**2318ADDSN - Addendum No. 1  
To Plans, Contract Documents and Specifications**

**Addison Municipal Airport (ADS)  
Taxiway B Extension – Phase I  
TxDOT CSJ No. 2318ADDSN**

**SAFETY END TREATMENT  
FOR BOX CULVERTS  
(MAXIMUM Hw = 7'-0")  
TYPE I ~ PARALLEL DRAINAGE**

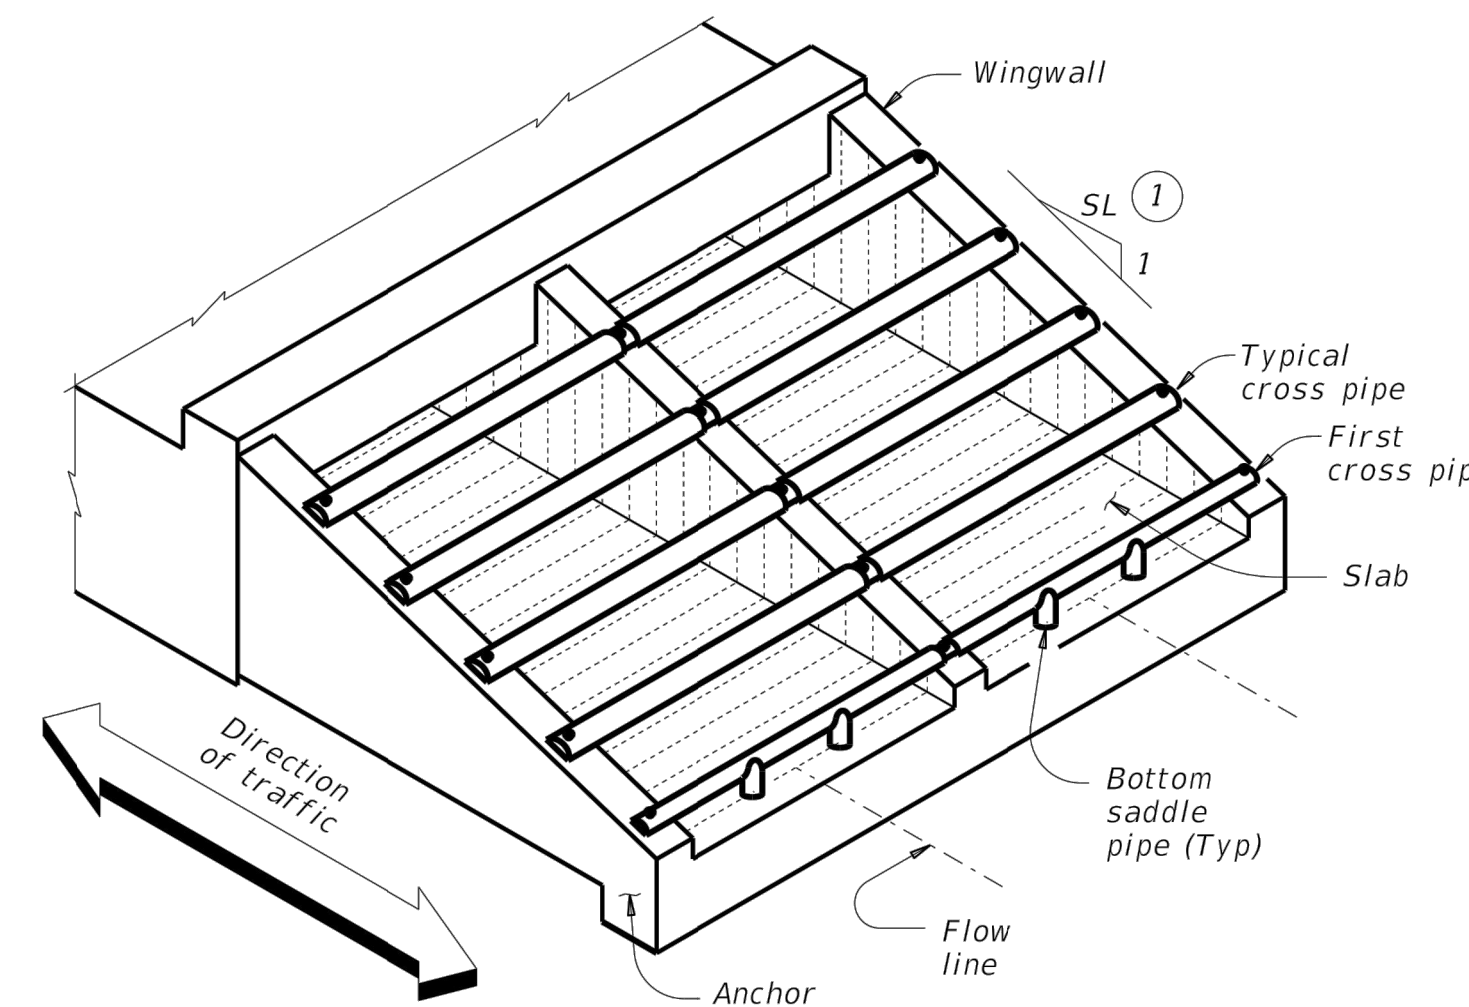
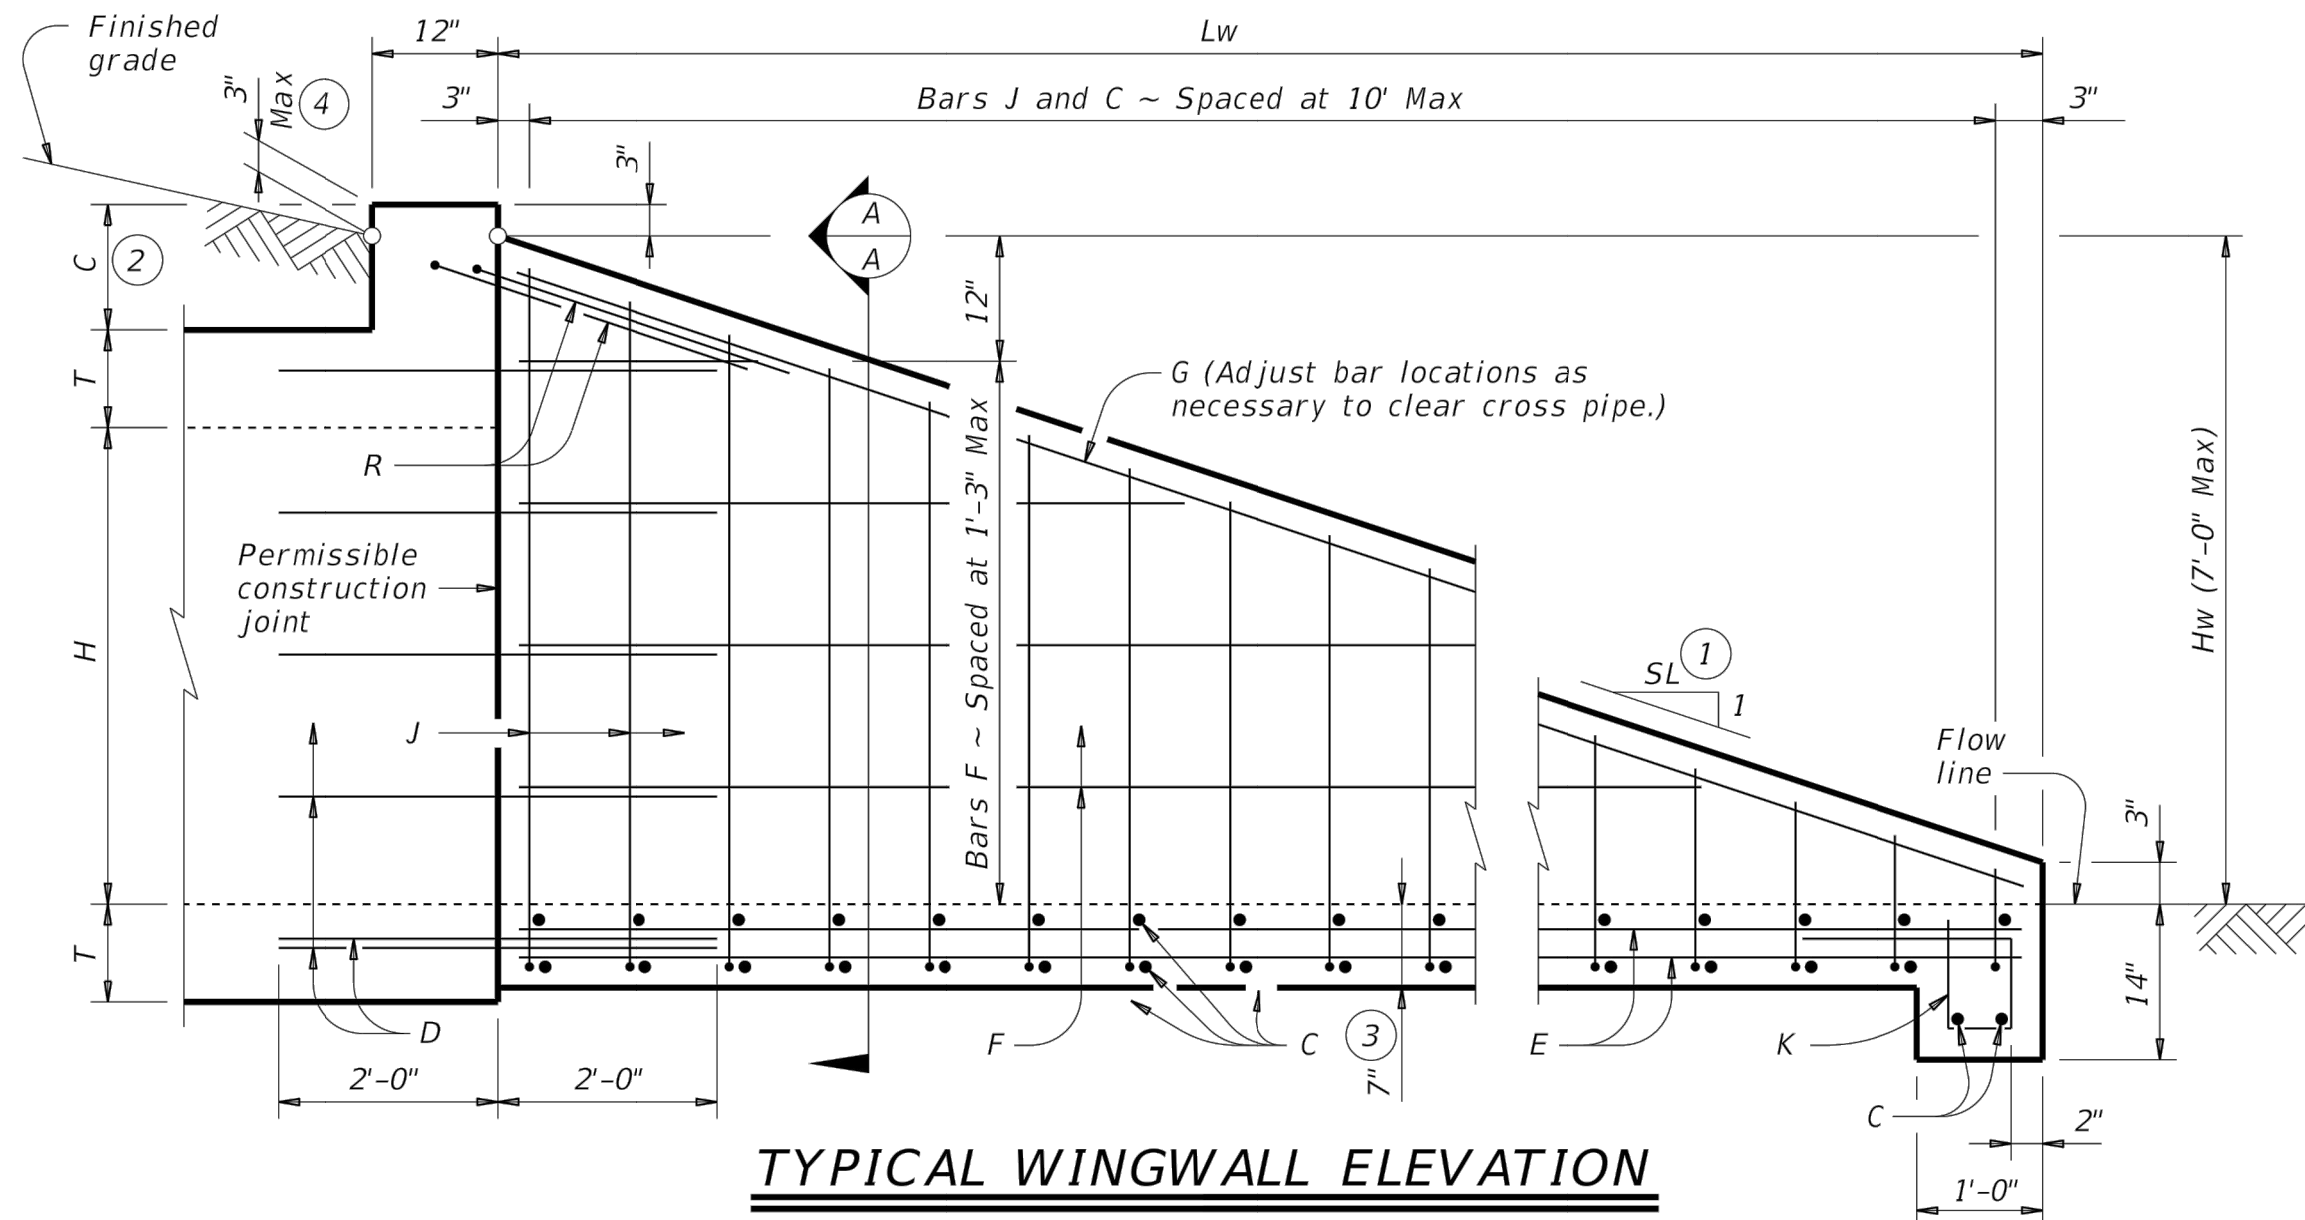
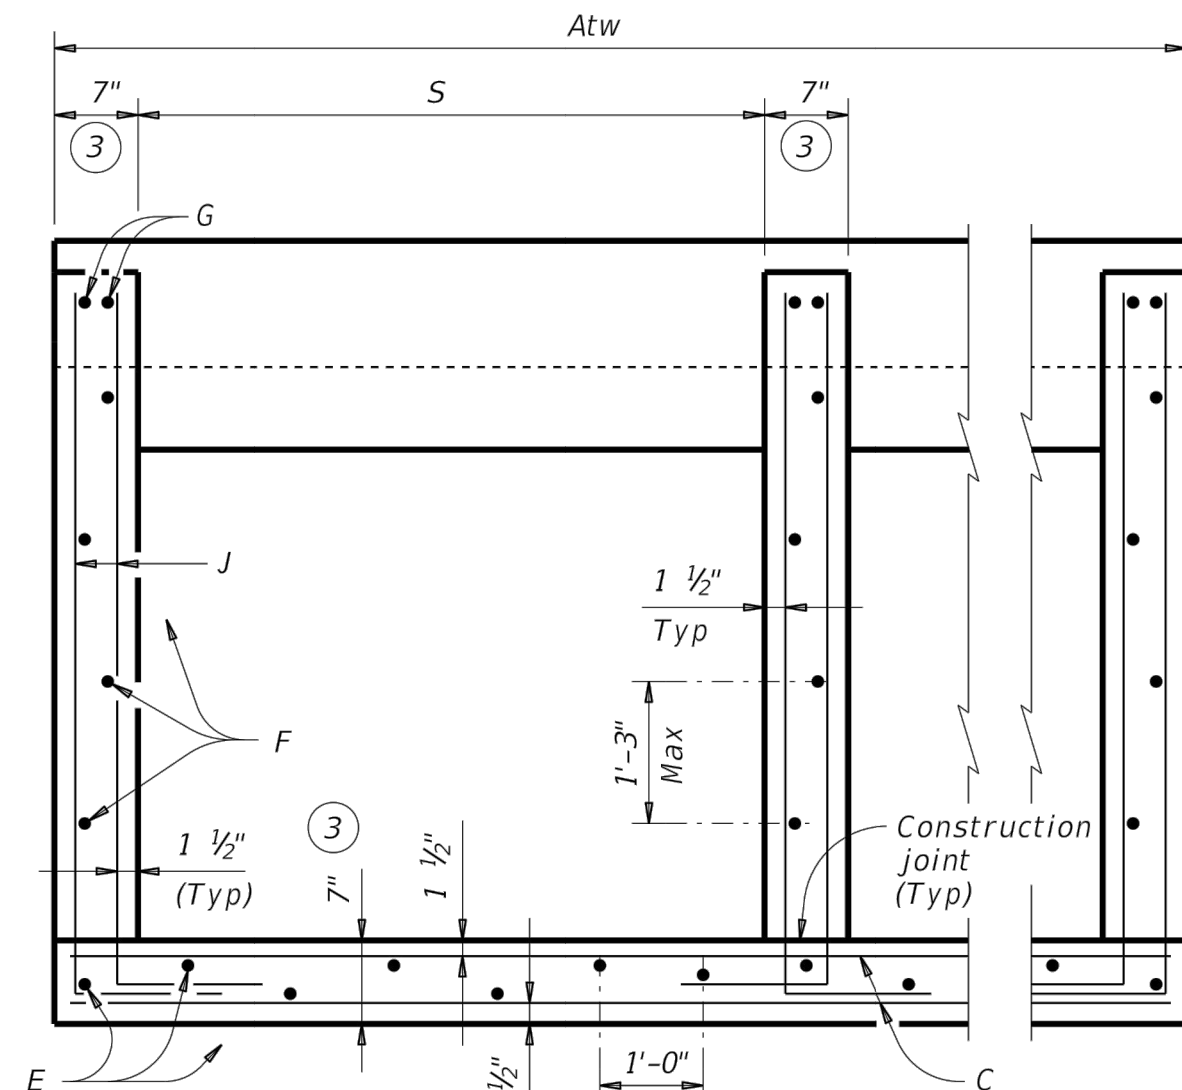
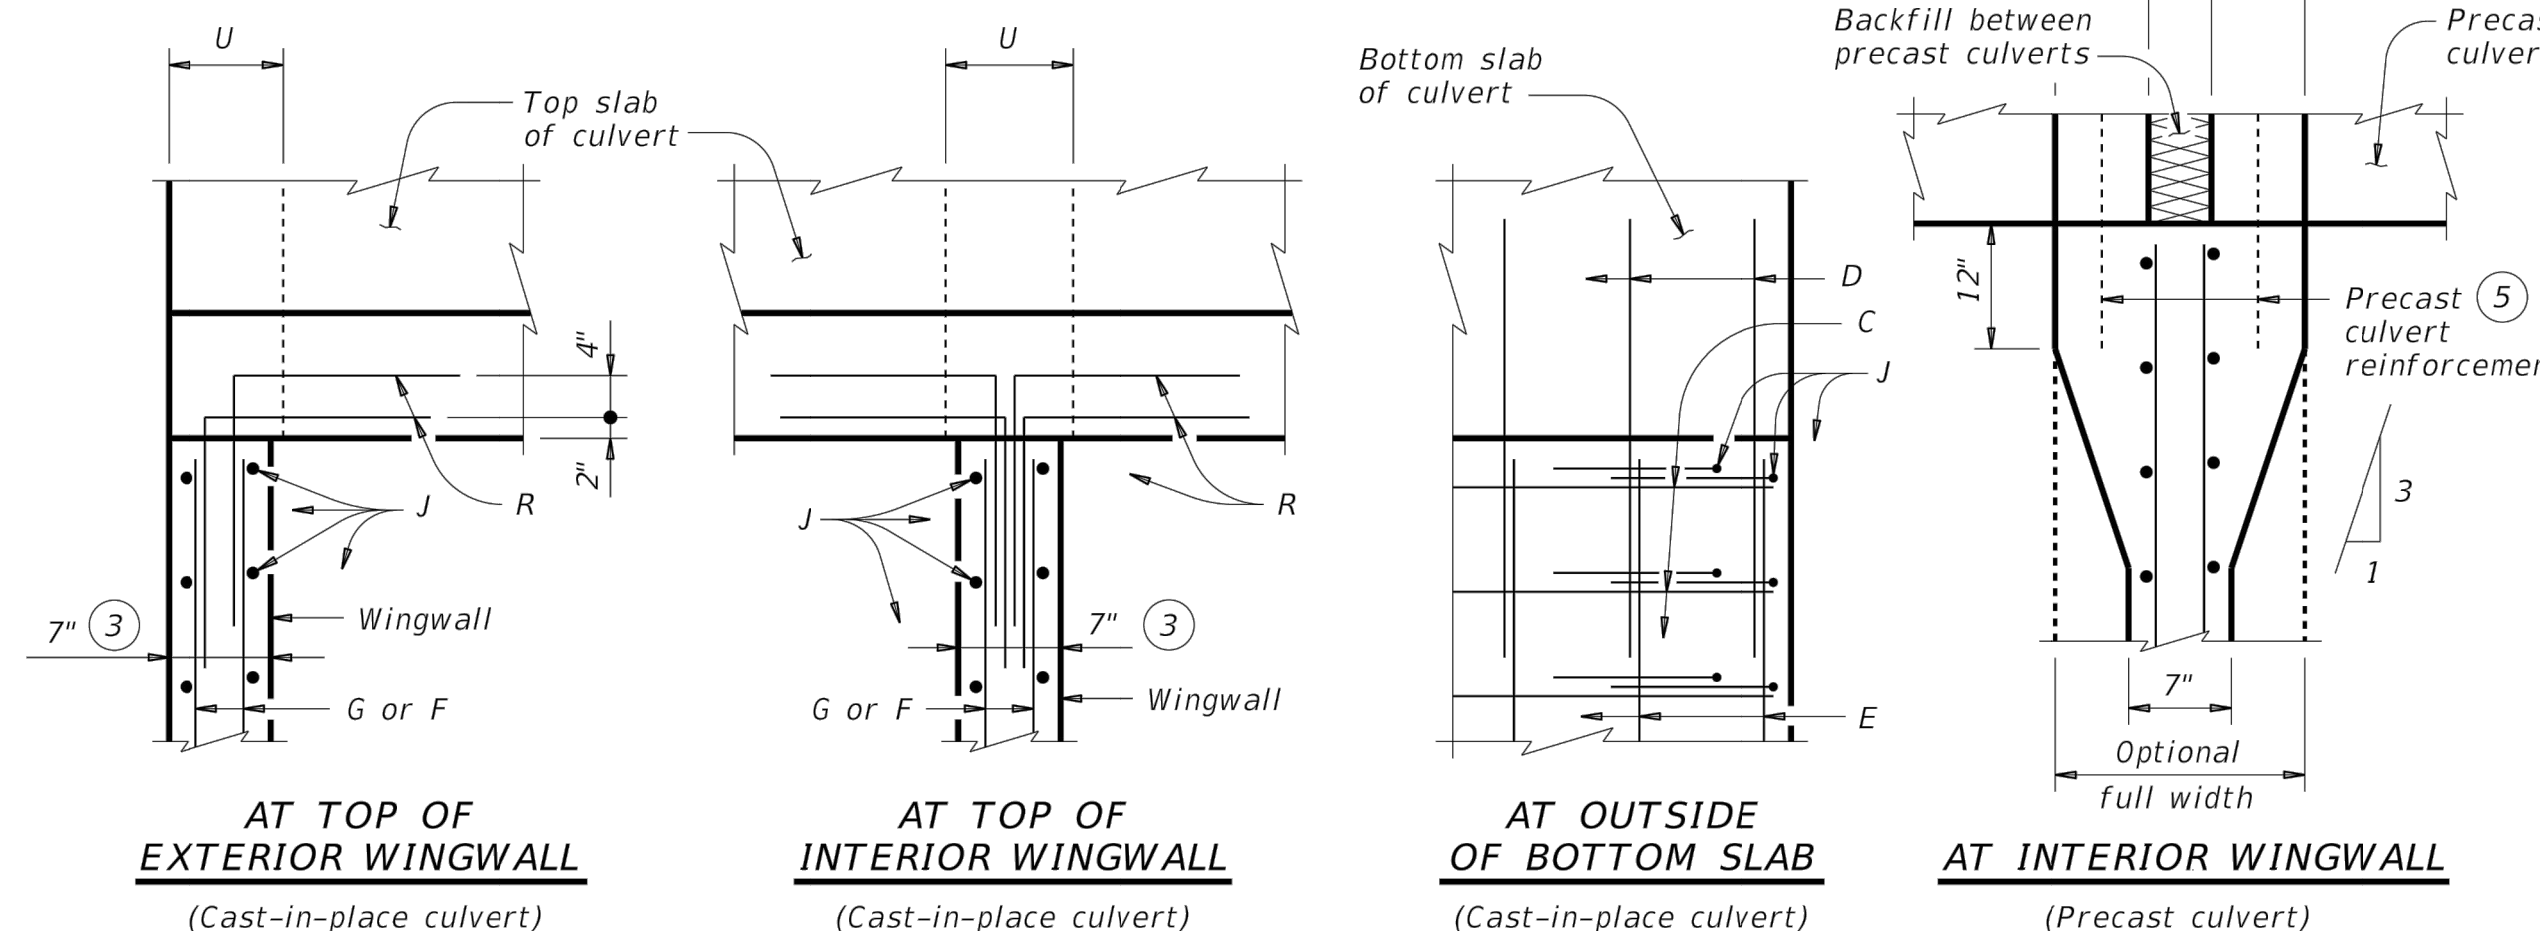
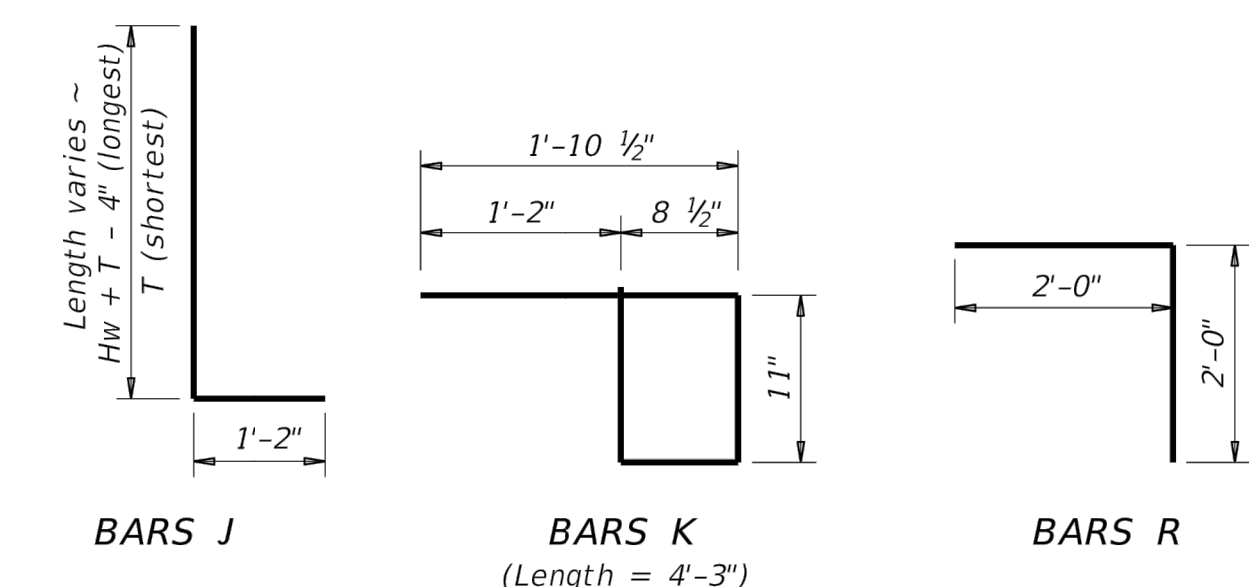
Sheet CC-502: The scale of the TxDOT detail was adjusted to properly fit the page.

- e) Sheets 38 – 40 did not plot correctly, can you reissue these?
  - Yes, these sheets will be corrected and reissued in Addendum No. 1.
- f) The hatch pattern for the Concrete Encased Pipe detail on plan sheet 162 is for CTB. The note says 6" Lime treated subgrade. Can you confirm which is required?
